# *I-65 TO US-31W CONNECTOR WARREN COUNTY, KENTUCKY*

Item Number 3-16.00  
VE Study Number 201108

Kentucky Transportation Cabinet  
Frankfort, Kentucky

**Final Report**

# VALUE ENGINEERING RECOMMENDATION # VE-1

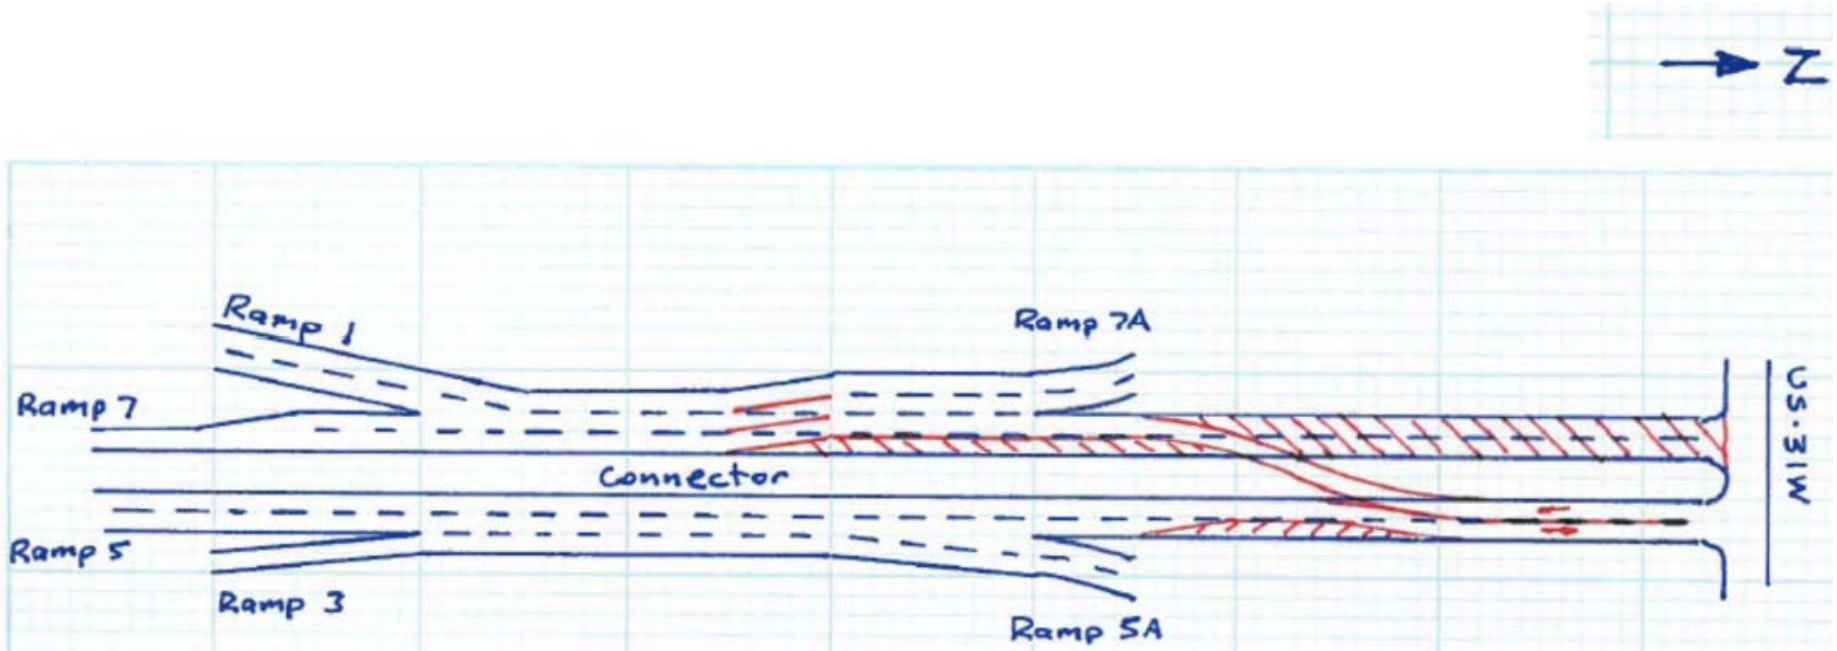
Utilize 2 ultimate lanes in lieu of 4 ultimate lanes from US68/KY80 to US-31W.

The original design specifies a total of four travel lanes for the Connector between US68/KY80 to US-31W (northern section).

The VE Team recommends the total number travel lanes to be reduced to two in the northern section. At Ramp 5A, there would be a two lane exit; the rightmost lane on the Connector would be an exit only lane and the center lane would have the option of continuing straight or exiting. The leftmost lane would be straight only. North of Ramp 5A, the two northbound lanes would merge into a single lane. Ramp 7A design would be two lanes and continue without merge along the one lane from the north to form three lanes.

The projected traffic volumes warrant a smaller number of lanes in the northern section. Preliminary capacity calculations show that two through lanes can accommodate traffic adequately. The costs can be reduced significantly while still meeting the basic needs of the project.

## VALUE ENGINEERING RECOMMENDATION # VE-2

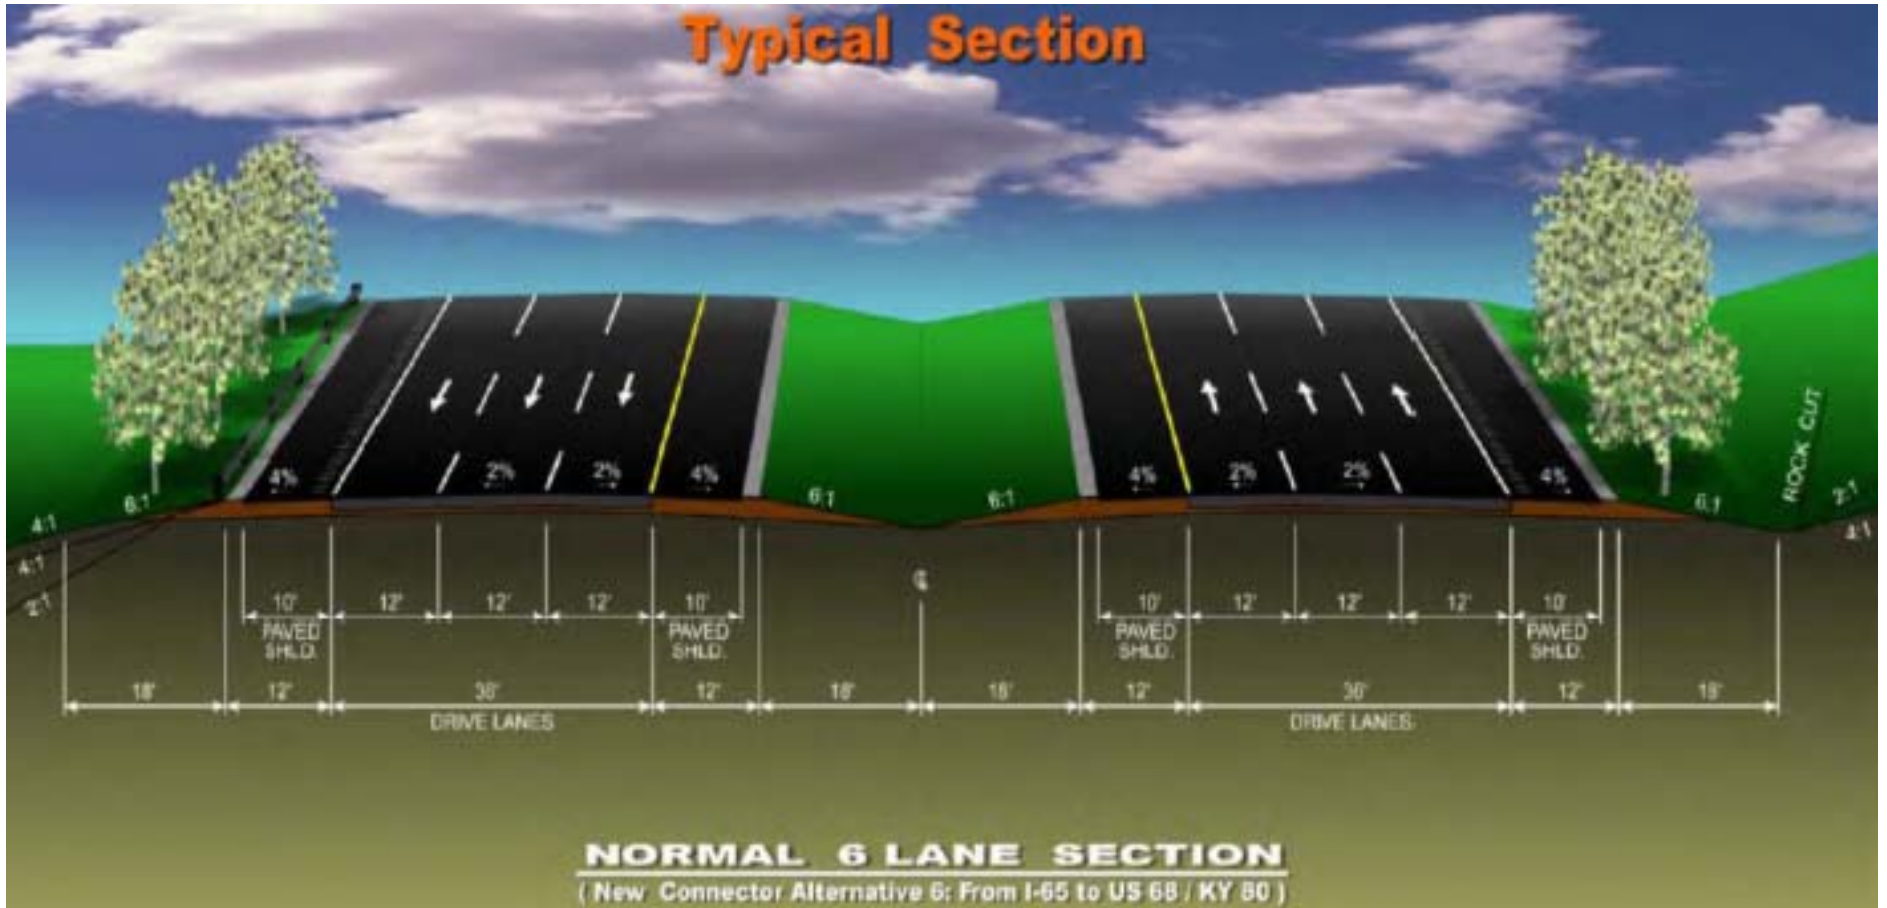
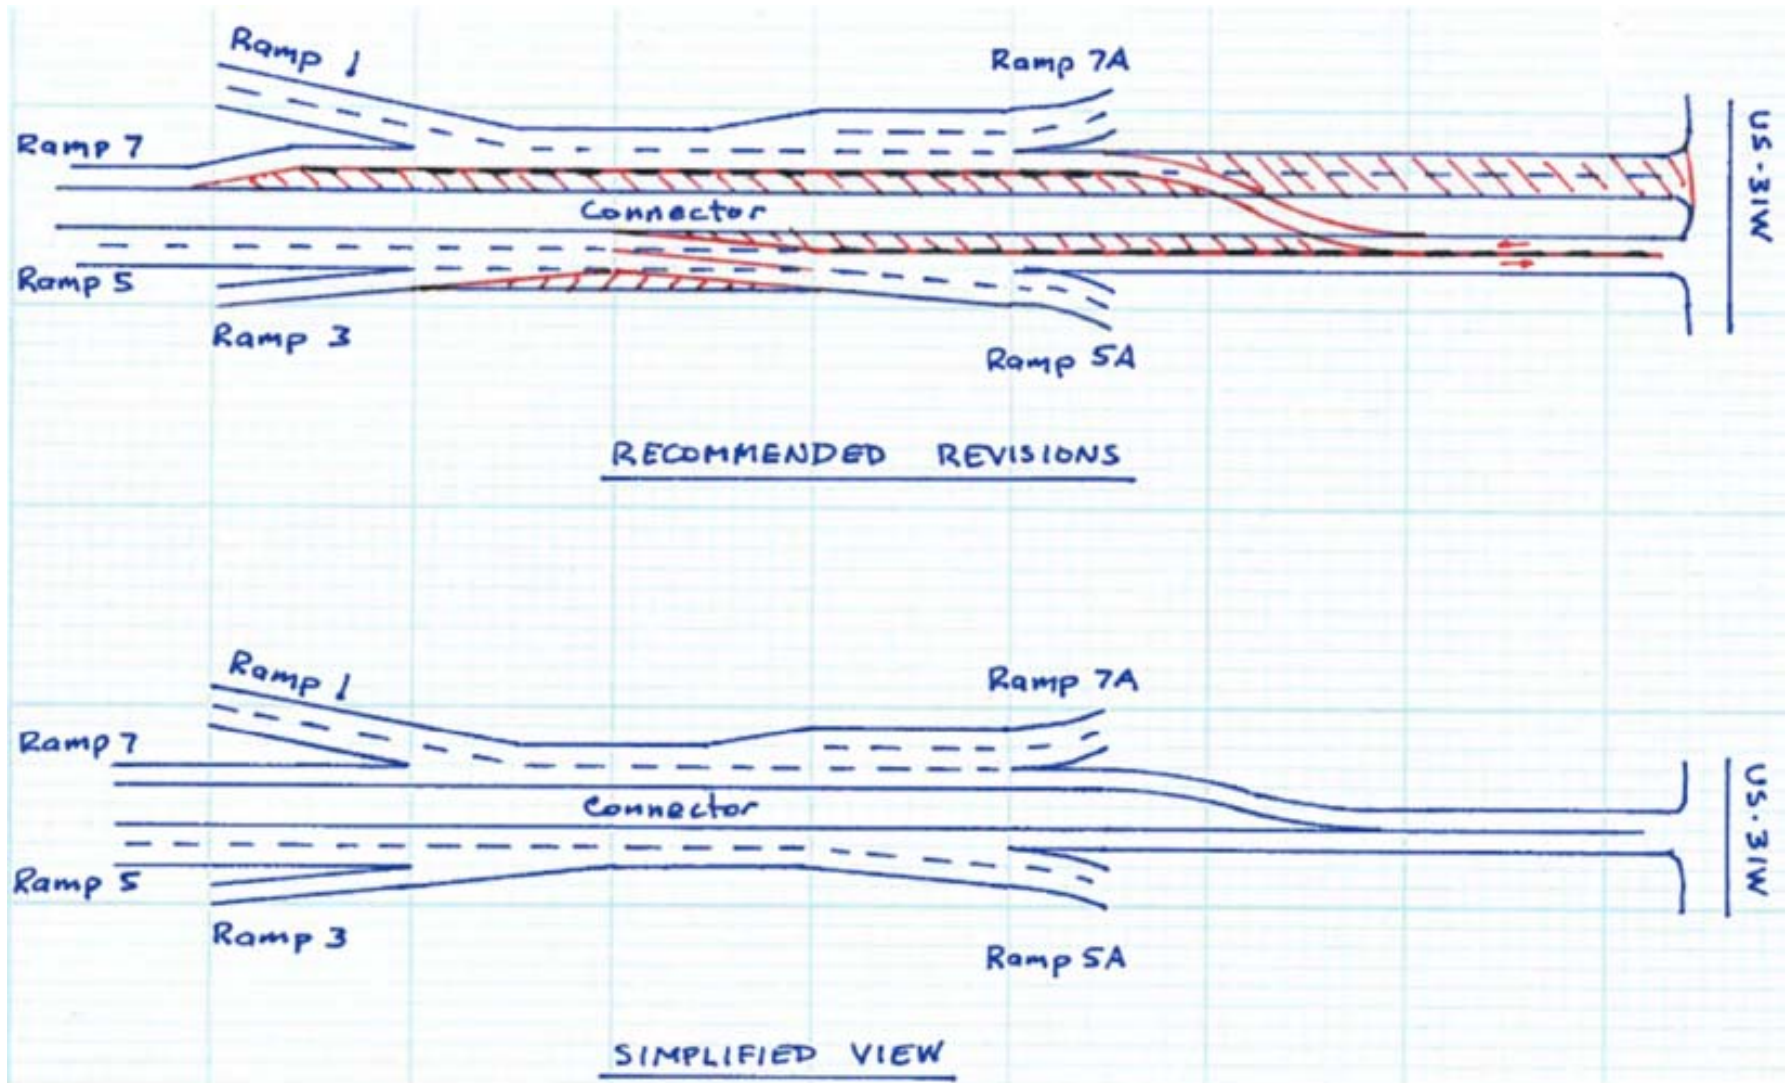
Utilize 4 ultimate lanes in lieu of 6 ultimate lanes from I-65 to US68/KY80 and utilize 2 ultimate lanes in lieu of 4 ultimate lanes from US68/KY80 to US-31W.

The original design specifies the road to contain a total of six travel lanes for the Connector between I-65 and US68/KY80 (southern section). It also specifies a total of four travel lanes for the Connector between US68/KY80 to US-31W (northern section).

The VE Team recommends the total number travel lanes to be reduced to four in the southern section and two in the northern section. Ramp 5 traffic would merge with the two lanes on Ramp 7 to form two lanes on the northbound Connector. At Ramp 5A, there would be a two-lane exit; the rightmost lane on the Connector would be an exit only lane and the leftmost lane would have the option of continuing straight or exiting.

The projected traffic volumes warrant a smaller number of lanes in both sections. Preliminary capacity calculations show that through lanes can accommodate traffic adequately. The costs can be reduced significantly while still meeting the basic needs of the project.

**VALUE ENGINEERING RECOMMENDATION # VE-3**

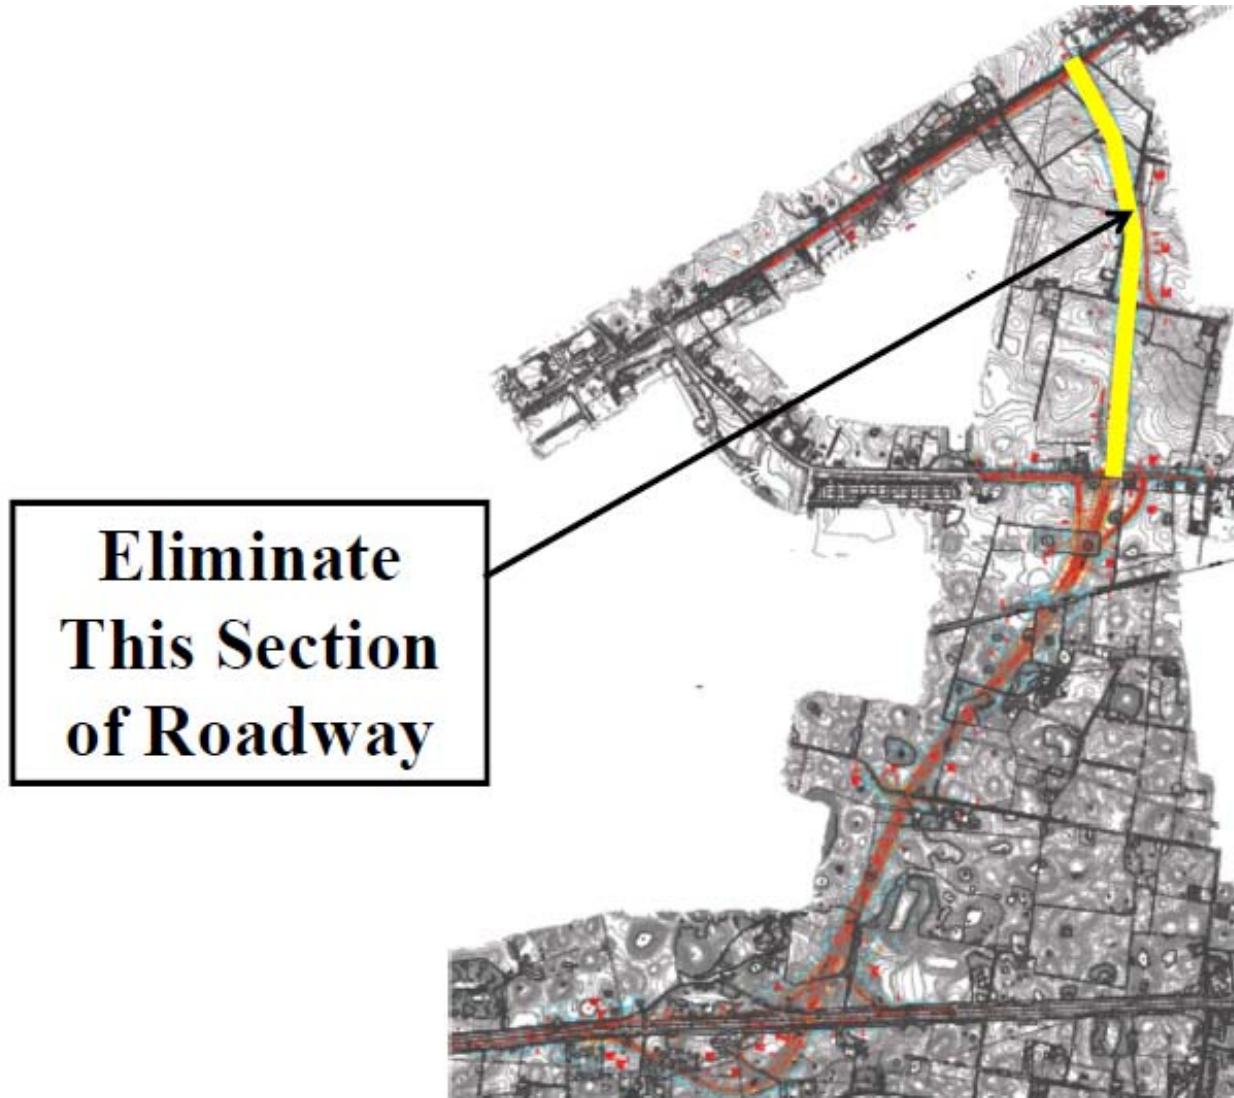
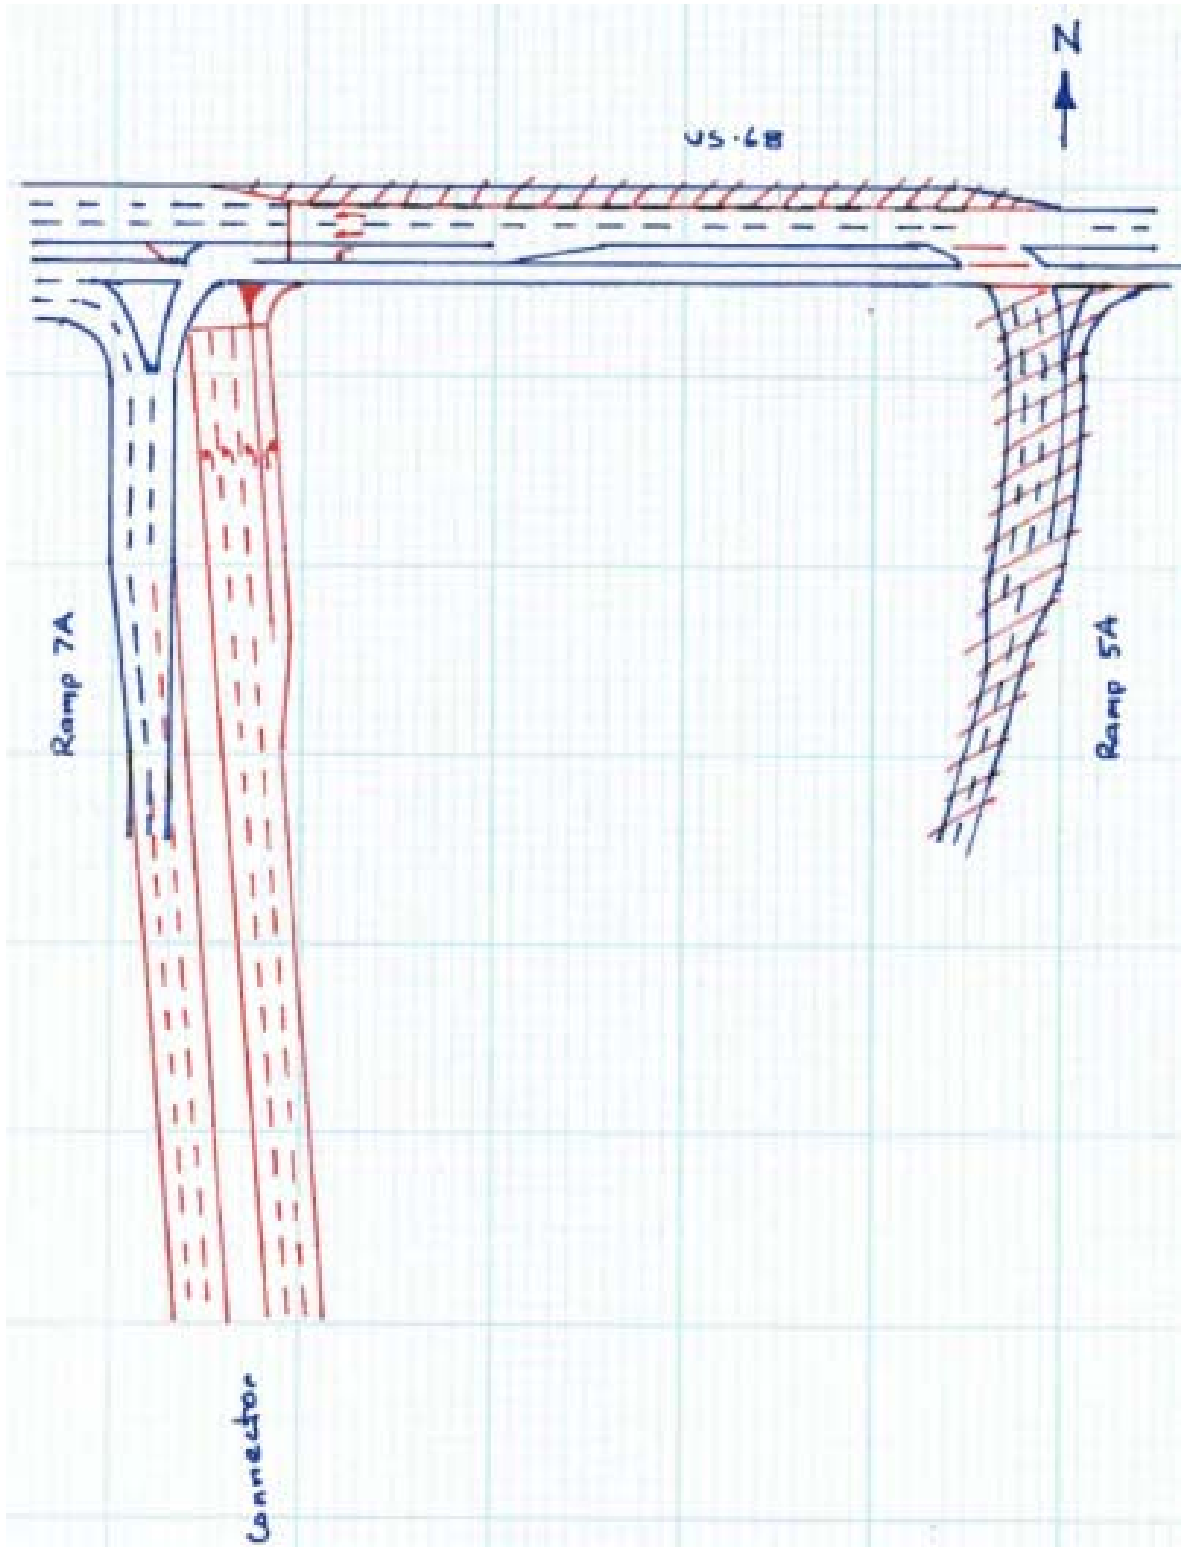
Eliminate the section of the project between US68/KY80 and US-31W and create an at-grade intersection at US68/KY80.

The VE Team recommends the northern section be eliminated and the interchange be converted to an at-grade intersection with US68/KY80. This can be done using one of two approaches:

- a. Build the ramps as designed, forming two intersections at the ramp terminals
- b. End the Connector at US68/KY80, forming a single T intersection.

VALUE ENGINEERING RECOMMENDATION # VE-4

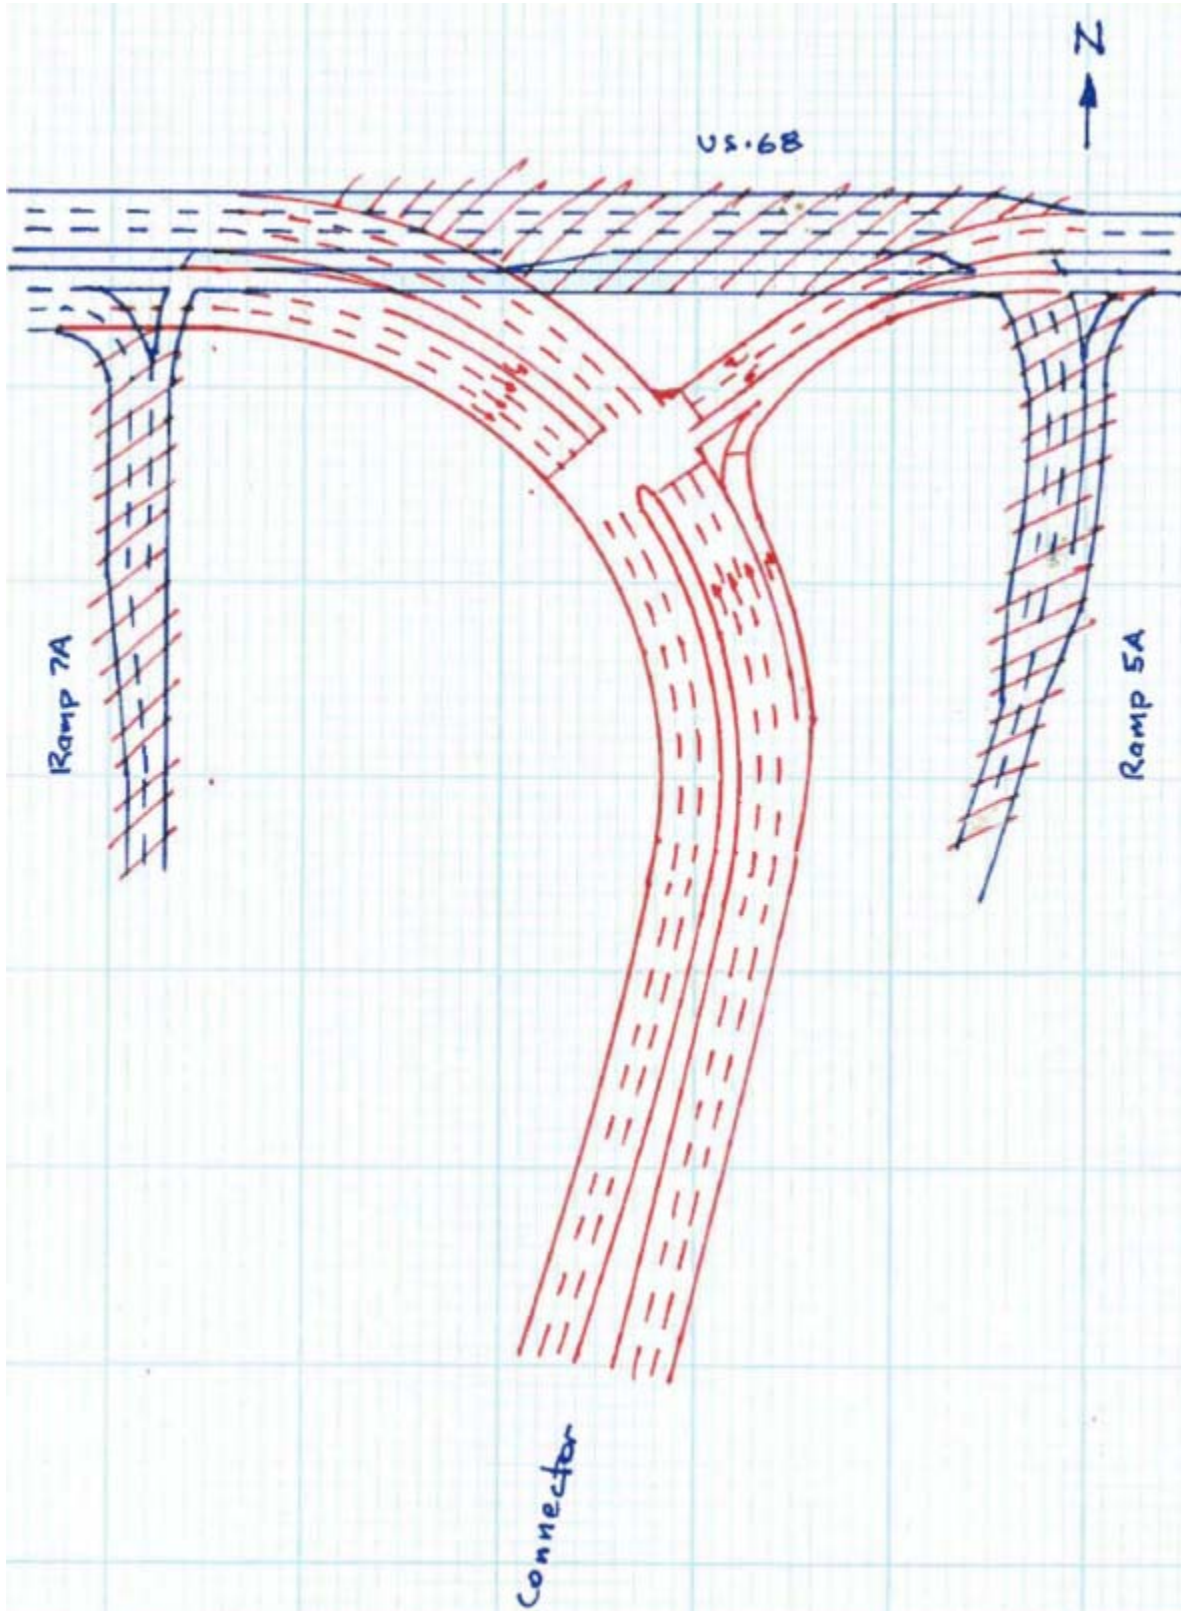
Eliminate the section of the project between US68/KY80 and US-31W. Reconfigure an at-grade intersection to “T” the eastern portion of US68/KY80.

The VE Team recommends the northern section be eliminated and the interchange be converted to an at-grade intersection with US68/KY80. US68/KY80 would be reconfigured so the eastern portion would form a T intersection at the Connector and the Connector would flow directly into the western portion of US68/KY80.
